I-35E

Parkway Design Concept Recommendation of the Saint Paul City Planning Commission

March 11, 1983

FIGURE II
 LOWER CATHEDRAL HILL
 DESIGN CONCEPT

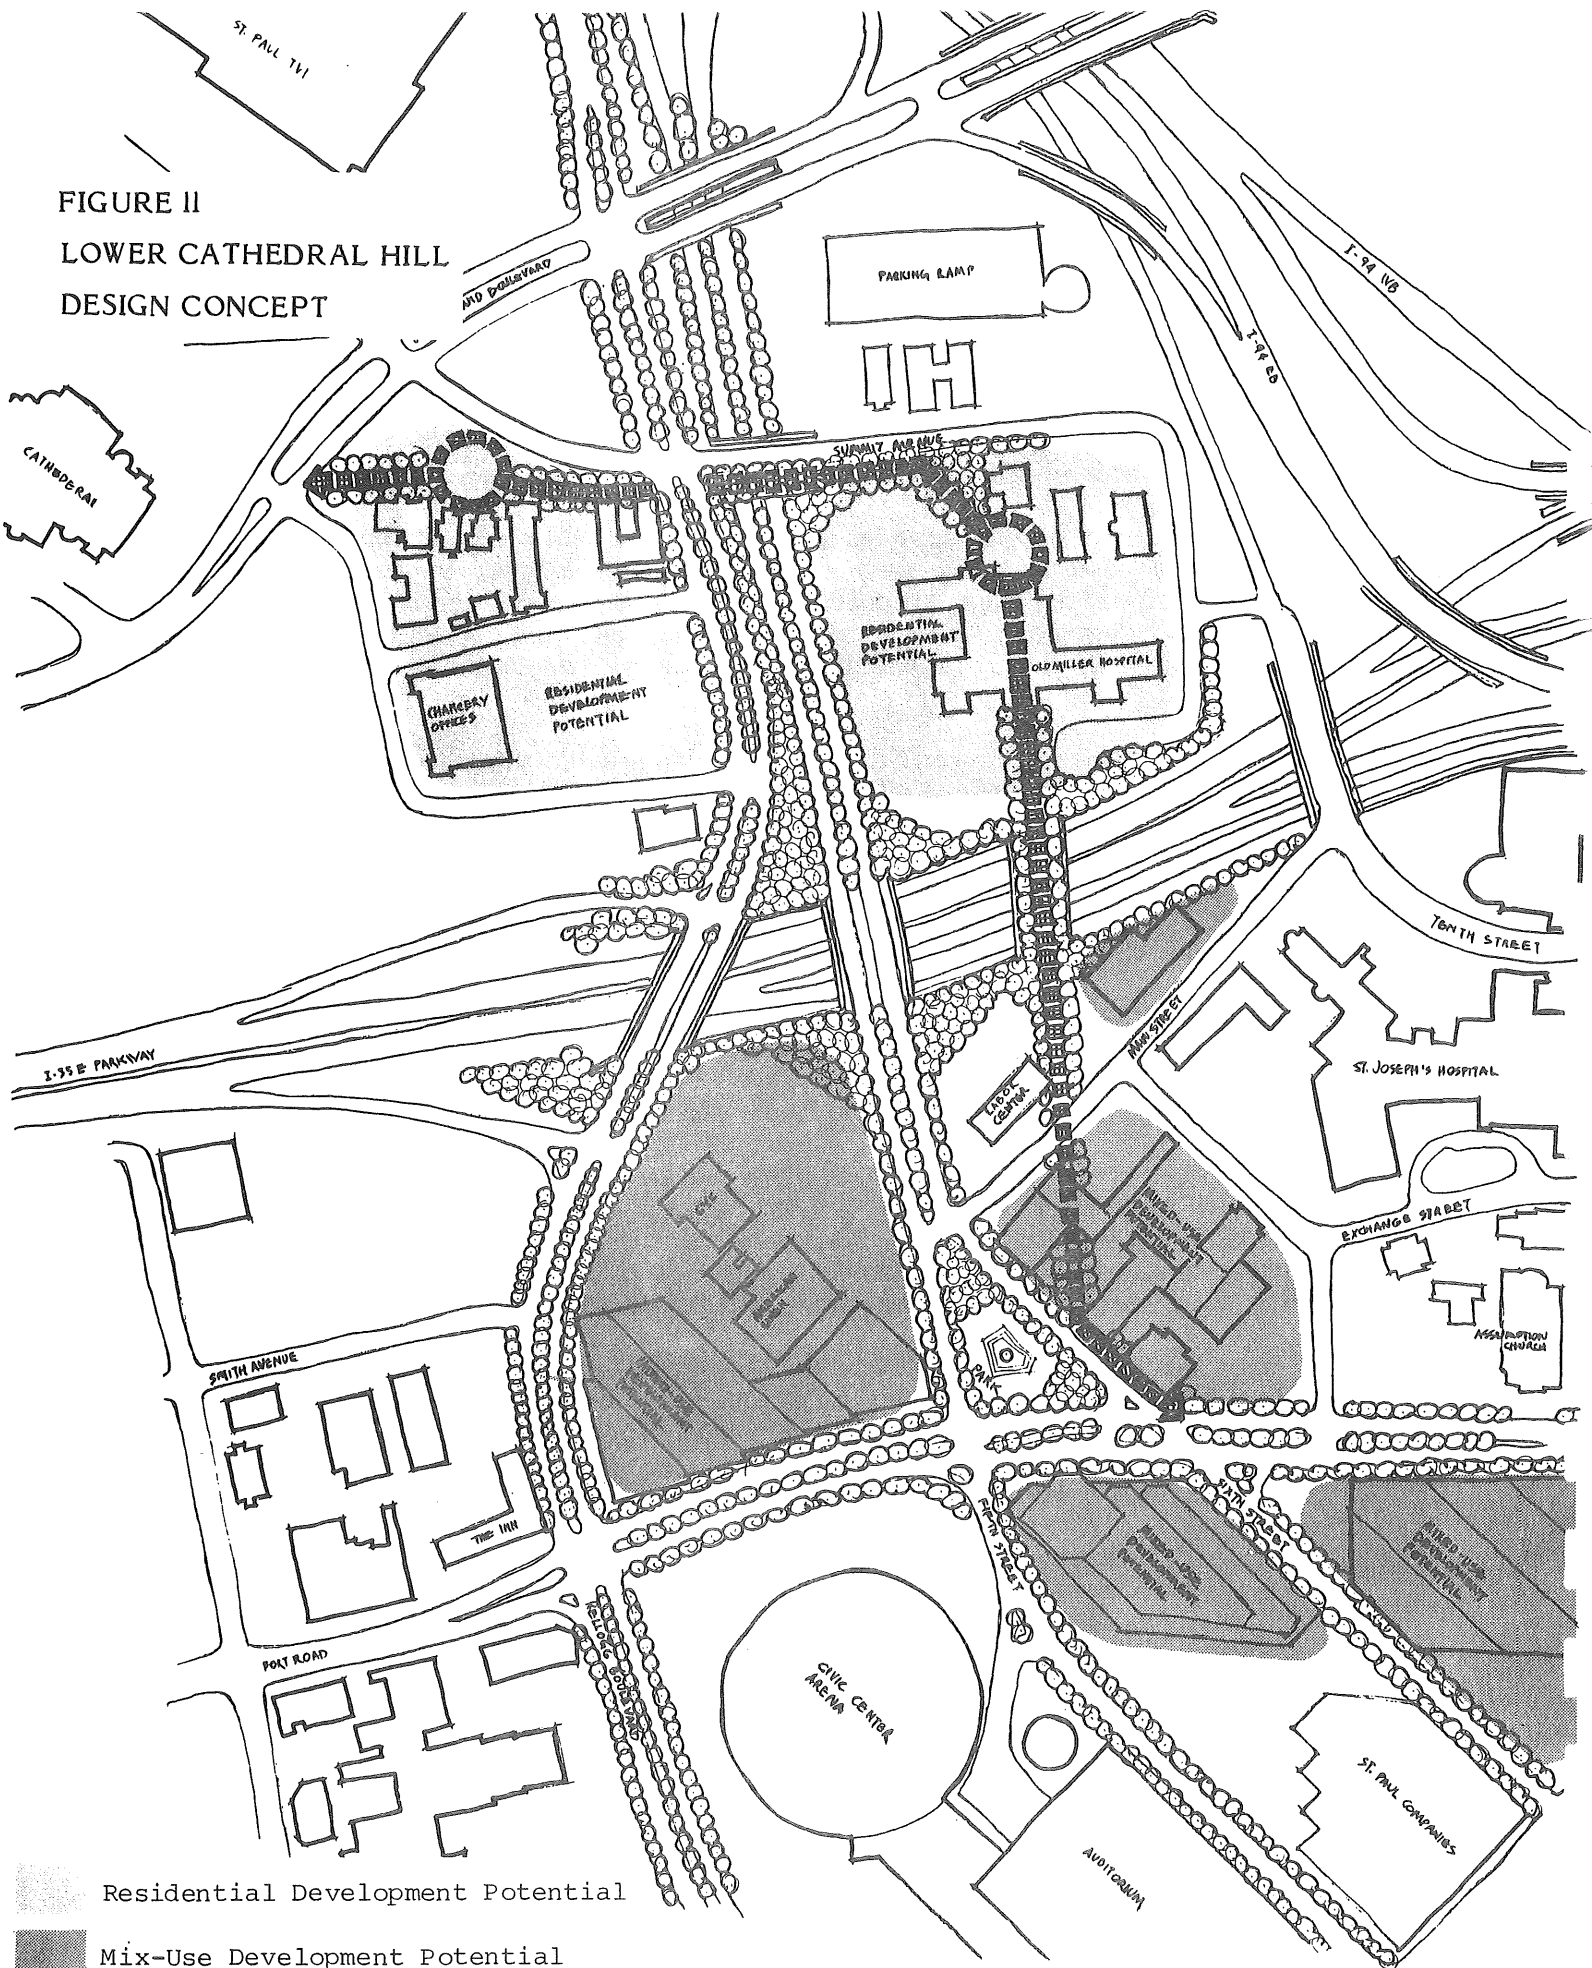
The resulting design concept for Lower Cathedral Hill recommended by the Commission (Figure 11) reflects a balance among these various concerns. An architectural concept of the gateway development potential of the area is presented in Figure 12. While it may well be several years before such development would be realized, many key elements will be provided through the completion of the parkway and the realignment of city streets.

Pedestrian connections are a particular concern. Although both the Parkway and the 5th/6th Street connection to I-94 will be depressed, minimizing the noise and visual impacts of these high volume roadways, they will present severe barriers to pedestrian movement. Sidewalks alone on Kellogg and Sixth Street will not be sufficient. Therefore, the design concept includes separate pedestrian crossings.

First, special attention should be given in the design of the new Summit Avenue bridge over 5th/6th Street to creating an attractive pedestrian link. When Miller Hospital is redeveloped as a residential community, this bridge will serve primarily as a driveway entrance to the site. It need not be as wide as a traditional city street and could be modified to a lower scale vehicular entry with the emphasis on pedestrian movement.

Second, provision of a pedestrian concourse across the parkway to preserve the pedestrian connection between the Miller Hospital area and downtown is critical. This should not be a typical pedestrian overpass but rather a special bridge wide enough to accommodate landscaping and other amenities. In the future, this bridge could be modified to provide an enclosed environment, integrated with development on either side of the parkway. In the short term, the concourse should be provided as part of the Parkway construction.

1. The basic design concept for Lower Cathedral Hill depicted in Figure 11 should serve as the guideline for the construction of the Parkway and Downtown street realignment.
2. A special pedestrian concourse should be constructed over the Parkway between Downtown and the Miller Hospital area. Funding from Federal and State sources in conjunction with I-35E funding should be provided.
3. The design of the Summit Avenue bridge should incorporate an attractive pedestrian link across Fifth/Sixth Street.

6. The basic design concept for Lower Cathedral Hill depicted in Figure 11 should serve as the guideline for the construction of the Parkway and downtown street realignment.
